**PREVOST**

**MAINTENANCE  
INFORMATION**

Mi97-16

<b>DATE:</b> 01-10-97	<b>SECTION:</b> 23
<b>SUBJECT:</b> Windshield washer system flow increase

FIGURE 1: H3 VEHICLE DRIVER AREA

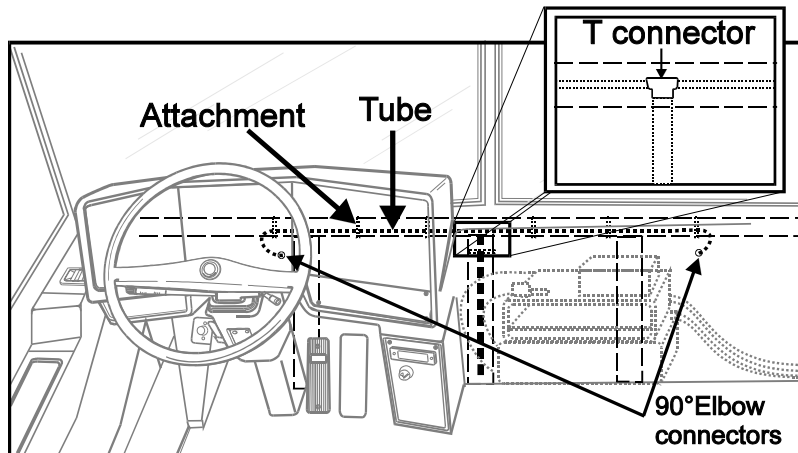
1. In order to access windshield washer tubes, remove front panel located on right side of dash (Fig. 1 & 2).
2. Remove all attachment, securing the two tubes located between T connector and wipers.
3. Remove the two tubes and the T connector.

4. Connect the new tubes (Prévost #300314 and #300315 for XL and #503002 for H3) on new T connector (Prévost #800322).
5. Secure tubes using attachment.
